Access Compliance Report

Public Rights-of-Way

Intersection ID: 9060	Main Street: DUNDEEN_ST	Cross Street: REDBUD_ST	Location: SE
ADA ID: 74108607C537	Ramp Type: Para	Initial Pass/Fail: Fail	Overall Compliance: No
			Severity Score: 26.25

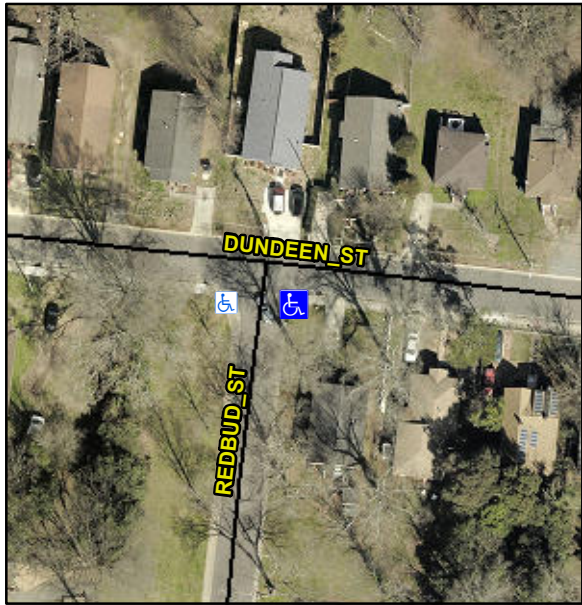
Codes/Mitigation Info/Possible Solution			Field Measurements/Component Compliance					
	Possible Solutions:		Compliance	Description	Data	Compliance	Description	Data
	Remove & Replace Entire Ramp.		N/A	Ramp Length LT (in)	36.0	N/A	Ramp Length RT (in)	36.0
			Yes	Ramp Width LT (in)	59.0	Yes	Ramp Width RT (in)	60.0
			No	Ramp Slope LT (%)	13.1	Yes	Ramp Slope RT (%)	1.3
			Yes	Ramp XSlope LT (%)	1.7	No	Ramp XSlope RT (%)	2.3
			N/A	Landing Length (in)	N/A	N/A	DWS Provided?	N/A
			N/A	Landing Width (in)	N/A	N/A	DWS Contrast?	N/A
			N/A	Landing Slope (%)	N/A	N/A	DWS Length (in)	N/A
			N/A	Landing X Slope (%)	N/A	N/A	DWS Full Width?	N/A
			N/A	Landing Curb? (Y/N)	N/A	N/A	DWS Offset (in)	N/A
Surveyor Notes:								
RT RP < 5%								
PROW/ADA:								
R304.3.2, R304.5.3
